## Grand Parkway SH 99 Segment B1 Project Details: Alignment Shift

SH 99 Segment B1 From I 45 to North of FM 2403 and SH 35 from N Gordon Street/BS 35-C to Steele Road

October 12 & 17, 2023

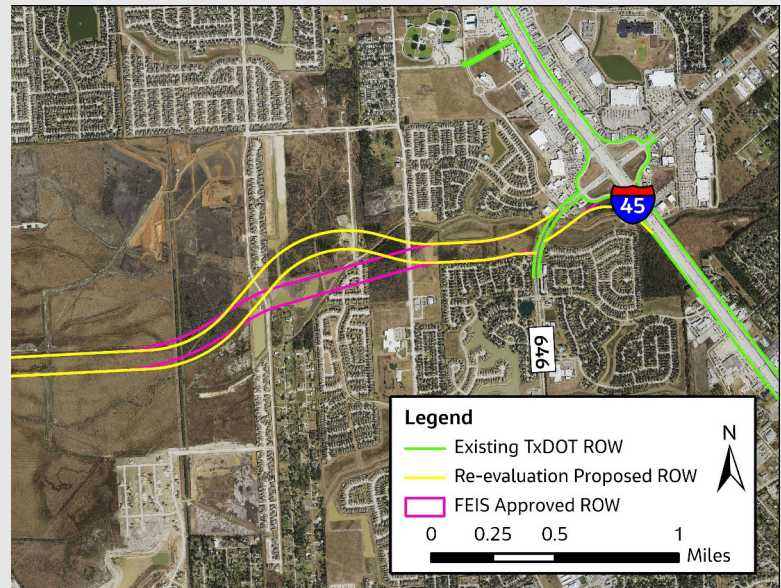
- An alignment shift between Calder Road and Hobbs Road was needed to avoid 26 recently constructed homes that were built within the approved FEIS/ROD preferred alignment.
- Alignment shift north would require 35 acres of additional right-of-way and effect 1 property not previously impacted.

There is a proposed alignment shift between Calder Road and Hobbs Road to avoid 26 new homes in the Bay Colony West subdivision that were constructed within the approved FEIS/ROD preferred alignment. The alignment would be shifted to the north along an alignment reviewed in the Draft EIS. This shift to the north to the Draft EIS alignment would require a re-evaluation of approximately 35 acres of right-of-way that was not in the FEIS/ROD approved alignment and would impact one property that was not previously impacted. There would be no additional displacements as a result of the proposed alignment shift.
